30/13-97C 4716 Waverly Avenue  
(Garrett Park Historic District)

## HISTORIC PRESERVATION COMMISSION STAFF REPORT

Case Number: 30/13-97C

PROPOSAL: Remove existing wood shingles roof,  
Install fiberglass shingle roof.

SIDE ELEVATION - EAST

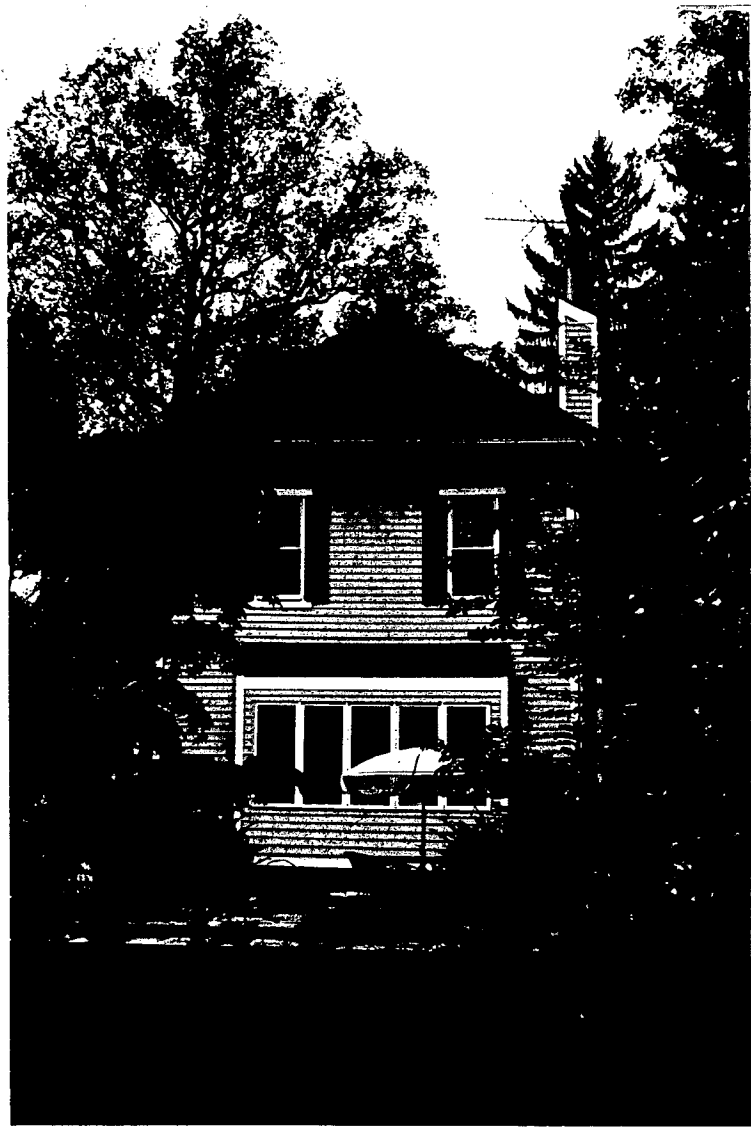
\* REPLACE BROKEN SHUTTERS

REAR ELEVATION

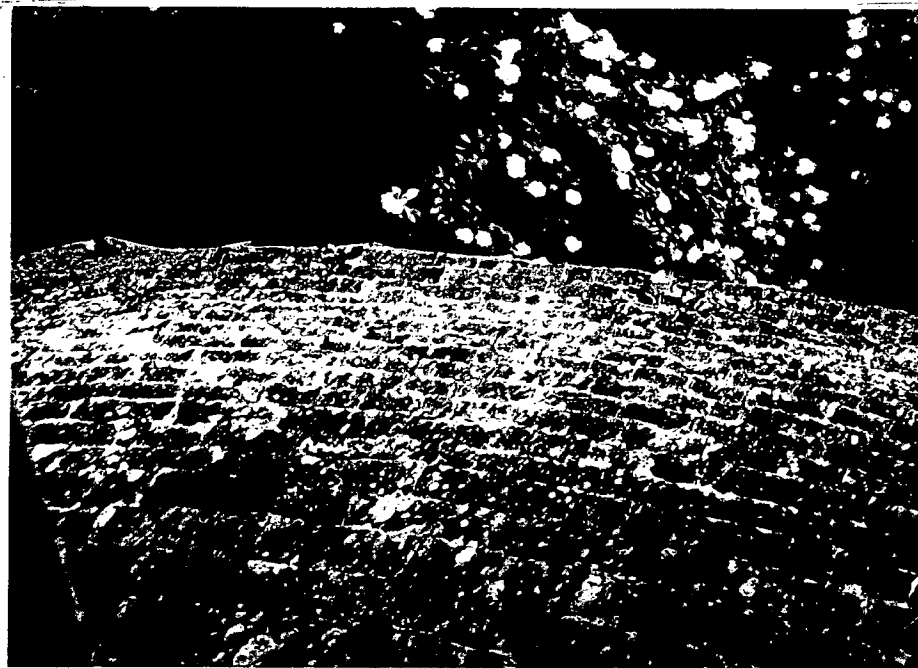
REPLACE EXISTING  
ROOF, GUTTERS &  
DOWNSPOUTS.
